2015.10.23 - Helium Polish version 5.6.79.1, report.dll version 2.7.3.1, BrilRecon.dll version 1.1.12.1, OHWS_reflect2.dll 1.5.63.533, new templates dd 15.09.2015

In this version we made following changes:

Report.dll 2.7.3.1	Report.dll 2.6.11.1
--------------------	---------------------

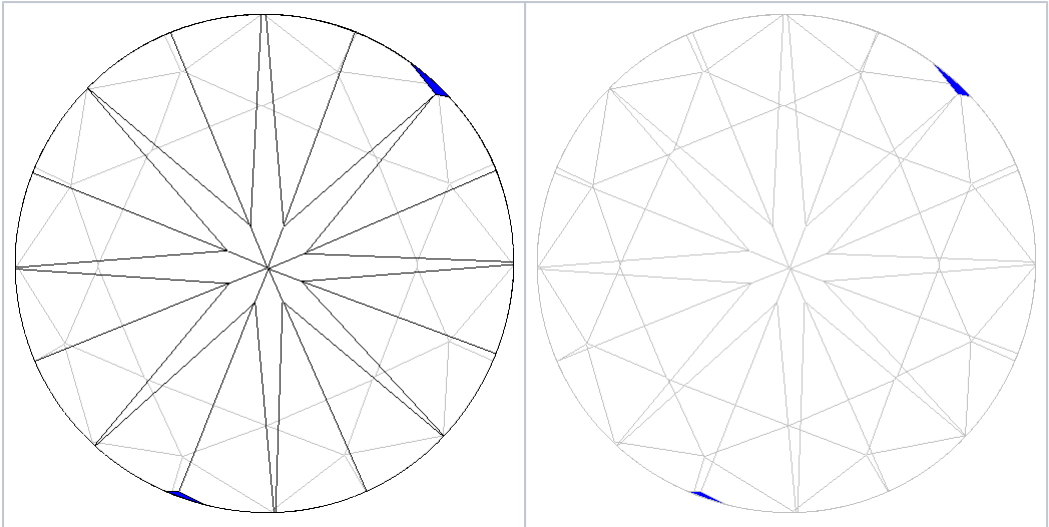
7. Problem with visible and invisible edges color is fixed. Visible edges had same color with invisible edges in report.dll 2.6.11.1. Fixed in report.dll 2.7.3.1:

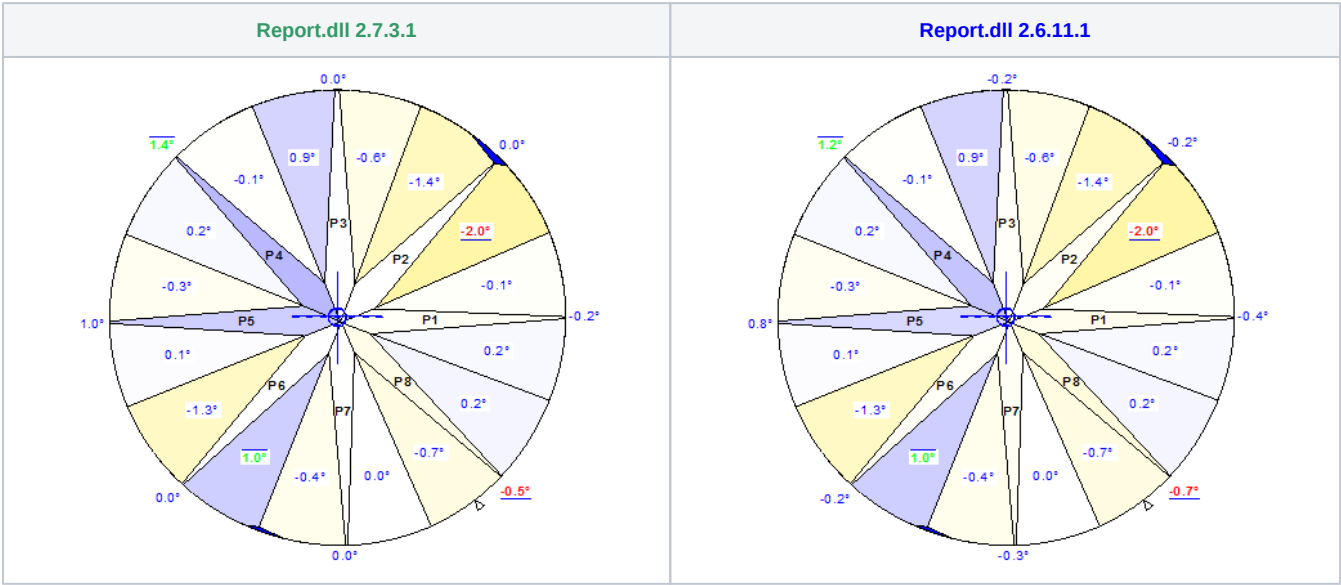
8. Change in calculation of "ideal" position for pictures «Pavilion/crown painting and deviation of pavilion/crown main facets azimuths angles from their ideal positions for the round brilliant». Before there was standard "net" 0, 45, 90, 135, ..., 315 degrees for "ideal" position. From this version program calculates position to minimize means-square deviation and to have as more as possible deviations which are closed to «0».

Changes are visible in Full report for bookmarks PAVILIONAZIMUTHDEV_REPORT_COLOR, CROWNAZIMUTHDEV_REPORT_COLOR, PAVILION_AZIMUTH_DEV_PICTURE, CROWN_AZIMUTH_DEV_PICTURE.

On example below, 4 facets deviations are equal to «0»:

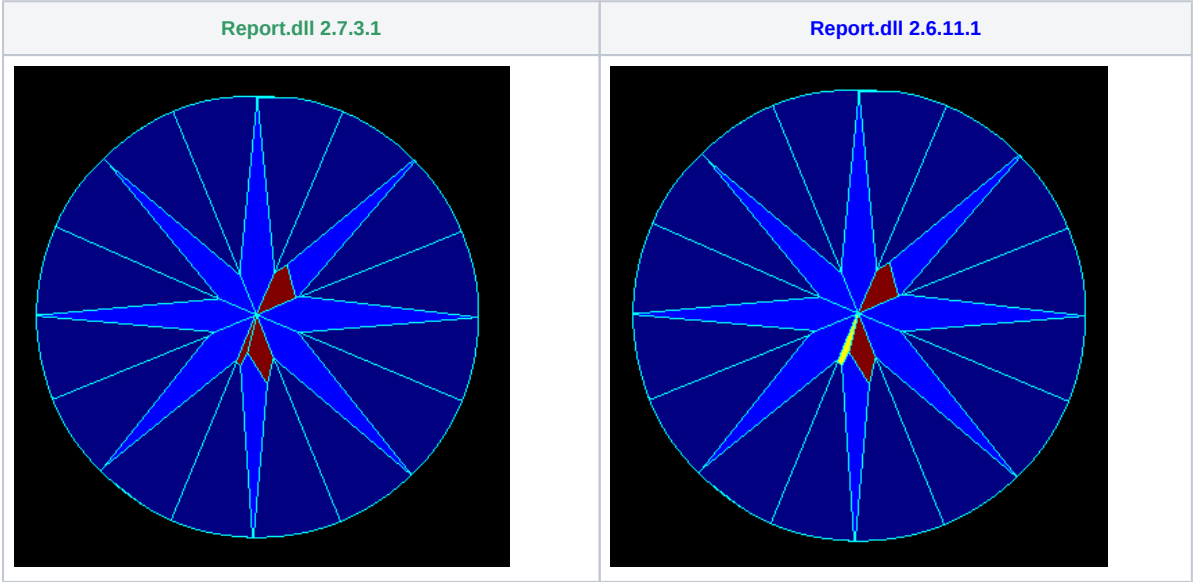
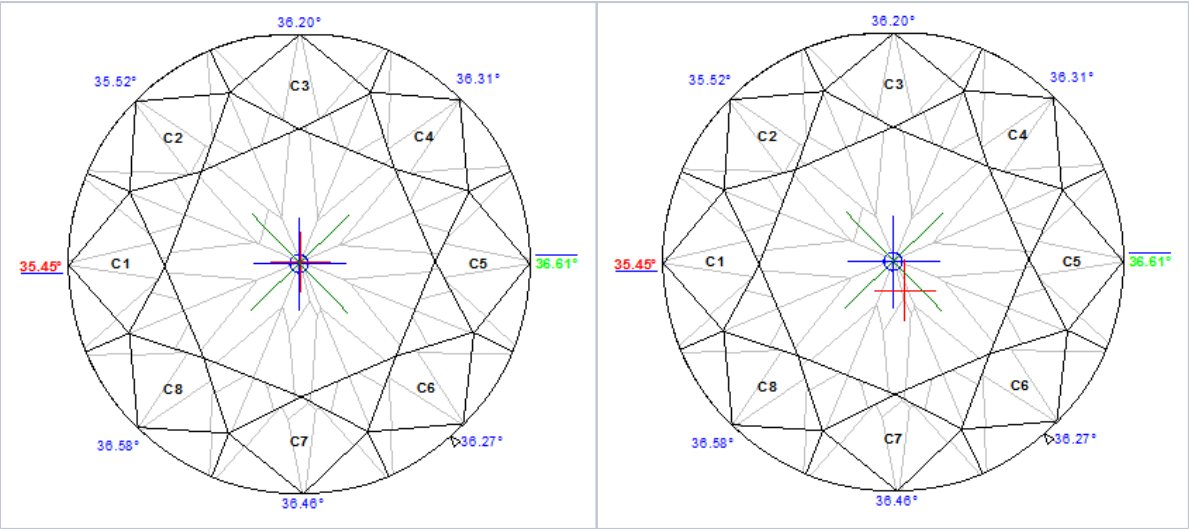
9. Bug with wrong detection of semi-polished *Heart* is fixed. In previous version (report.dll 2.6.11.1) semi-polished heart was recognized as *Oval* cut. From current version (report.dll 2.7.3.1) semi-polished heart is recognized as *Heart* cut.
